Warranty Bulletin

WB17-81A

REVISION A : THIS WARRANTY BULLETIN SUPERSEDES PREVIOUS VERSION.
Steps15-17 order rearranged

MCM SERVICE SWITCH FUNCTIONALITY- CORRECTIVE MEASURE ON I-START
EQUIPPED VEHICLES
9700 (B13R)

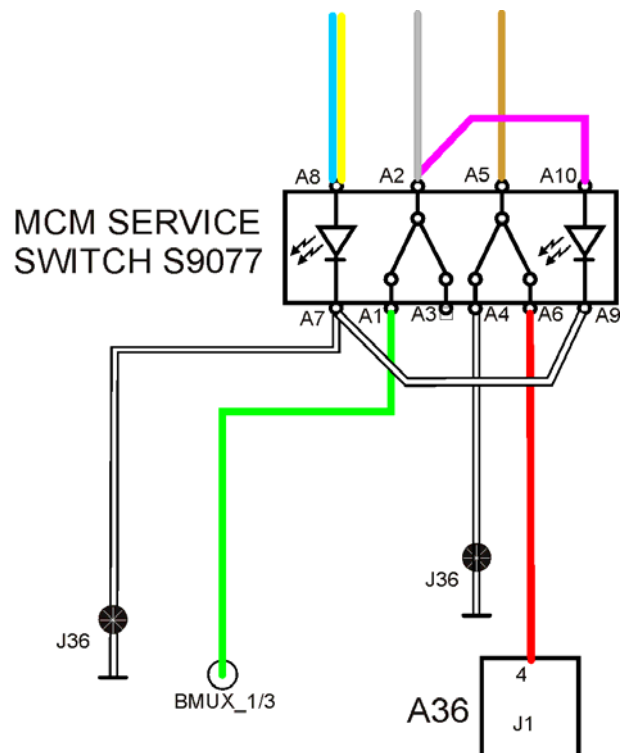
- 4) Disconnect the **purple wire** at cavity **A1**
- 5) Disconnect the **gray wire** at cavity **A2** and cut off end terminal. Double crimp **gray wire** with the **purple wire from A10** using terminal #970745 and then connect to cavity **A2**.
- 6) Cut the **white wire** routed between A9 and MCM module (A36) at about 6 inches from S9077.
- 7) Seal off the white wire end routed to MCM (A36) or remove this wire completely.
- 8) Disconnect the **white wire** at cavity **A7** and cut off end terminal. Double crimp the **white wire** with the **white wire from A9** using terminal #970745 and then connect to cavity **A7**.

Before

After

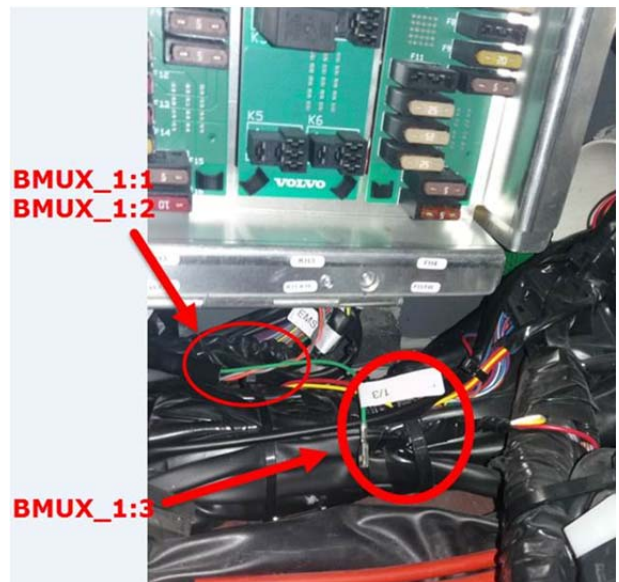
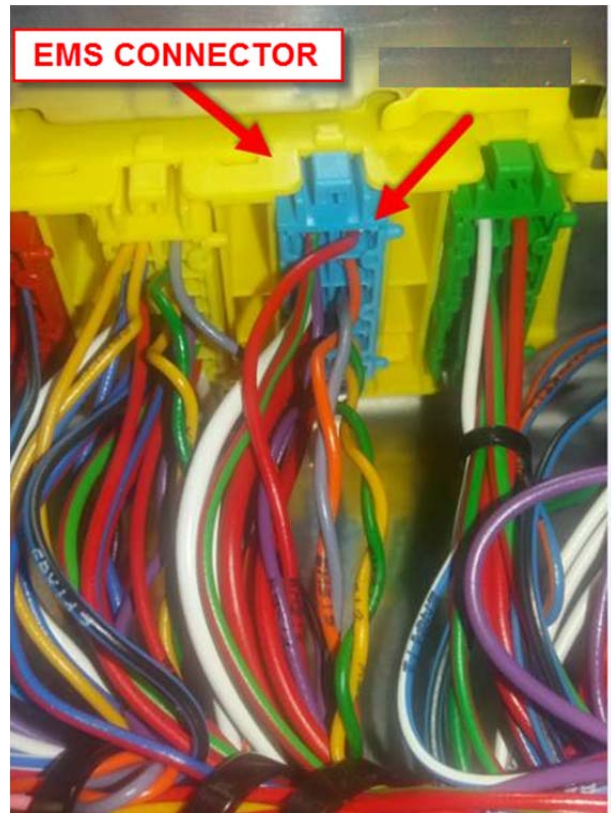
- 9) Locate the following wires and PVC pipe:
BMUX_1/1 (Grey),
BMUX_1/2 (Orange),
BMUX_1/3 (Green) wires.

NOTE: (orange & grey wires are twisted together)

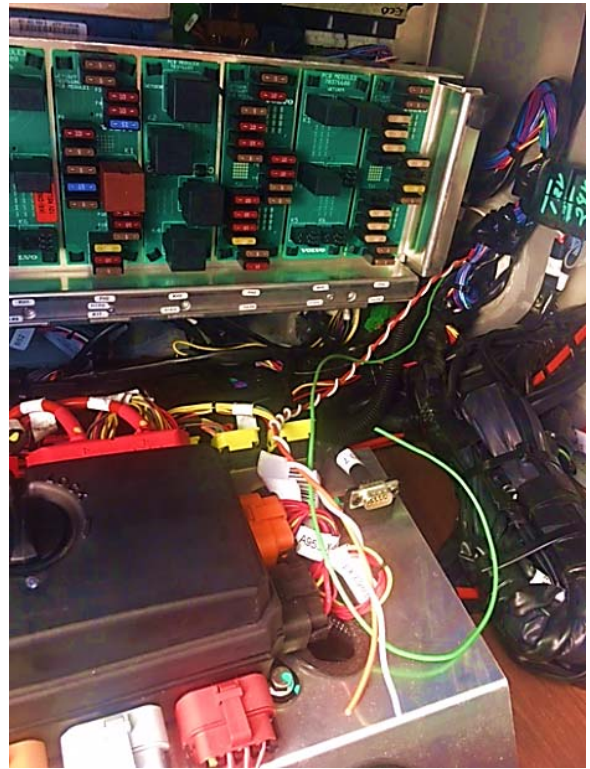
- 10) Disconnect BMUX/1 and BMUX/2 (orange & grey wires twisted together) wires from EMS connector.

- 11) Extend BMUX/1, BMUX/2, BMUX_1/3 using splice #956956 and corresponding color coded wire. IMPORTANT: Read the note below.

Note: BMUX/1 & BMUX/2 (orange & grey wires) must be twisted together: twist pitch 9.2 turns/ft (30 turns/meter), that makes 75 turns for 98" long wire.

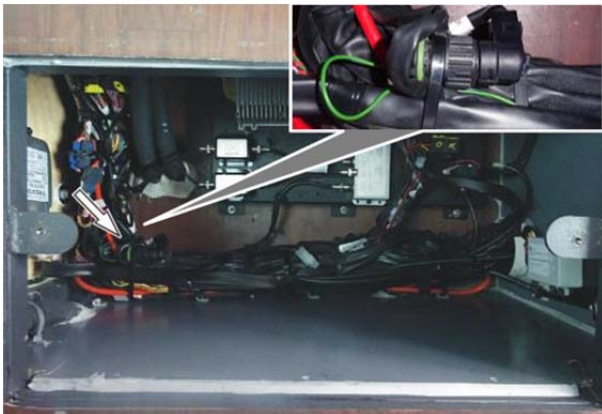
Note: Use nylon ties along the routing line as required.

- 12) Open the service hatch behind driver seat.
- 13) Install BMUX connector (**#25371156**). Route wires in PVC pipe in order to reach BMUX connector.
